DEPARTMENT OF TRANSPORTATION**Federal Aviation Administration****14 CFR Part 93**

[Docket No. FAA-2003-14715; Amendment No. 93-83]

Noise Limitations for Aircraft Operations in the Vicinity of Grand Canyon National Park

ACTION: Final rule.

Figure 1. Comparison of GCNP Quiet Aircraft Technology Designation with Audibility

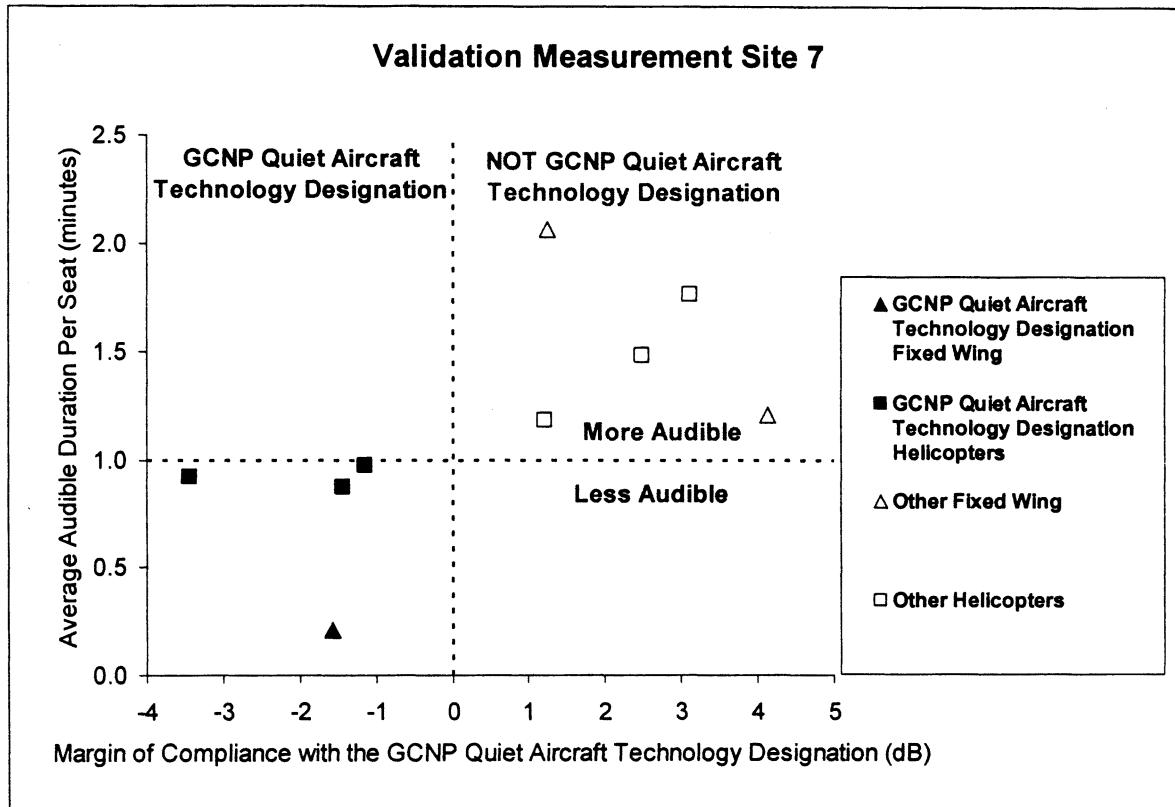
The NPS recommends that the FAA perform an analysis to ensure that aircraft that the FAA has classified as GCNP quiet aircraft technology based upon certificated noise levels are less audible than aircraft not so classified. The NPS included with its comment a technical memorandum, "Relationship Between Audibility of Tour Aircraft and Certification Data," prepared by the aviation environmental consulting firm, Harris Miller Miller & Hanson, Inc. (HMM&H).

To address the NPS concern, the FAA performed a comprehensive assessment of the subject relationship utilizing the capabilities of the FAA's Integrated Noise Model (INM) Version 6.2. The FAA finds that the designation of reasonably achievable GCNP quiet aircraft technology correlates sufficiently with audibility to assist the FAA and NPS in fulfilling the National Park Overflights Act (Pub. L. 100-91).

Just as was done by the consultant (HMM&H) for the preparation of the NPS comment to the SNPRM Notice No. 03-05, the FAA evaluated the ranking of aircraft audibility duration per available passenger seat against the ranking of the noise certification level in A-weighted decibels per available passenger seat. The FAA performed this evaluation at the 39 measurement sites in the GCNP noise model validation study (labeled as '1A', '2A', * * * to '9F' in the study). Similar to what the NPS's consultant had done, the FAA generated figures that compare the aircraft's margin of compliance with the GCNP quiet aircraft technology designation to the length of time the aircraft is audible, adjusting for the number of available passenger seats.

The margin of compliance is the difference in decibels between the aircraft's certificated noise level and the GCNP quiet aircraft technology designation noise limit, using the appropriate equation in the proposed rule. A negative margin of compliance means that the certificated noise level is below the noise limit designating that aircraft as GCNP quiet aircraft technology. In this evaluation, the Vistaliner, EC-130, MD600 and MD900 all have negative margins of compliance (GCNP quiet aircraft technology designation); while the C182, C207, AS350, B206B, and B206L all have positive margins of compliance (not GCNP quiet aircraft technology designation).

Figure 1 compares the margins of compliance to the average length of time audible for the sample of aircraft at validation measurement Site 7. While Site 7 has been singled out for display, the findings are comparable to the other validation measurement sites. Site 7 included 6 microphone locations along Tanner Trail in the GCNP. The average audibility duration value at the 6 microphone locations is plotted for each of the aircraft types. The helicopters and fixed wing aircraft that meet the GCNP quiet aircraft technology designation are less audible than those aircraft that do not meet the designation.

The FAA concludes that while the correlation between ranking of certification noise levels and ranking of audibility duration is inexact, aircraft that meet the GCNP quiet aircraft technology designation are consistently less audible than those that do not. Therefore it is reasonable to expect that replacing non-compliant aircraft with larger, GCNP quiet aircraft technology designation aircraft (e.g., replace a
